With reference to the received queries the Organiser has provided the following new materials (appendices) available at <https://pliki.um.warszawa.pl/index.php/s/CMJ9AFyvCMQYwKK> (i.e. the link sent to the Participants together with the invitation to submit a competition work):

**Question No. 1.** Please provide a list of all the documents that may be downloaded from the Competition website.

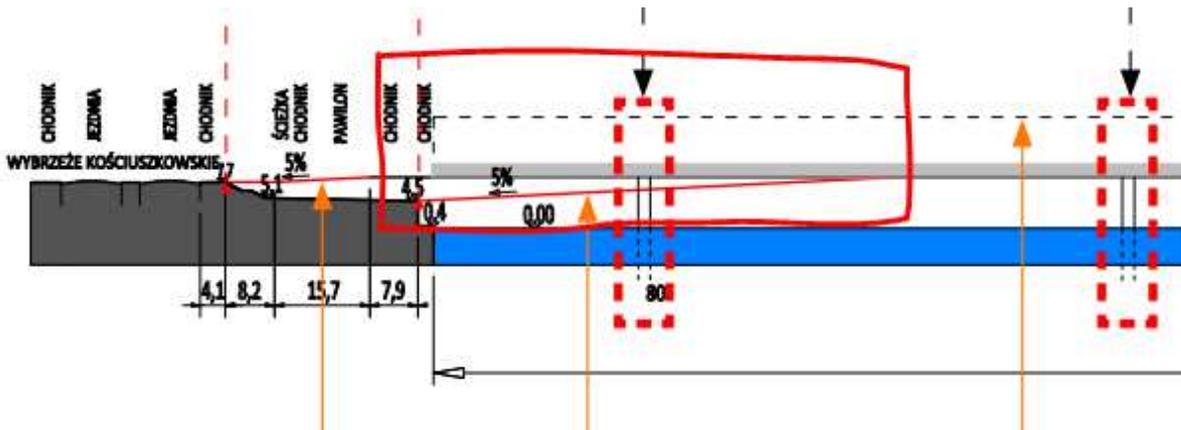
**Question No. 47.** If the bridge is to consist of several lanes separated from each other, is the criterion of the minimum width of 6 meters to be understood as the minimum for each lane or as the total width of all the lanes put together in the cross-section?

*The minimum usable width for the pedestrian and cyclist lane is 6 m. With the cyclist traffic separated from the pedestrian one, the minimum usable widths are respectively: 3.4 m for the cycling route and 3.0 m for the pedestrian path. When designing the geometry, it is necessary to take into account the requirement specified in Section 4.4, Chapter II of the Terms and Conditions, i.e. to ensure the passage of special-purpose vehicles.*

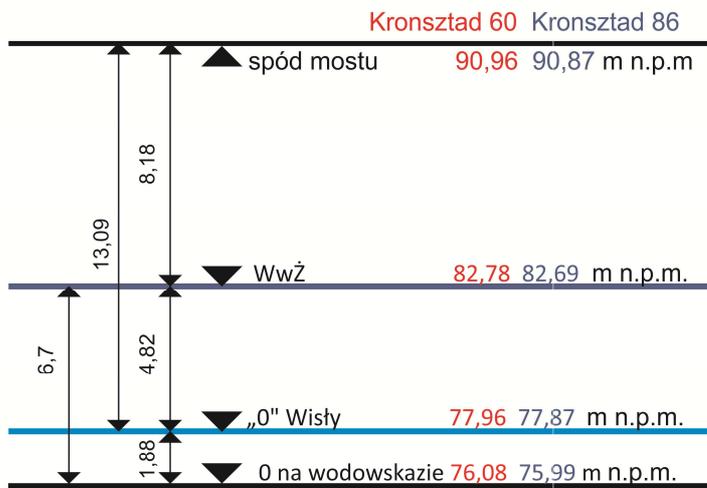
**Question No. 71.** Please specify the system of altitude measurements for the map presented in Appendix A.

*The system used in the map refers to the level of the Vistula River.*
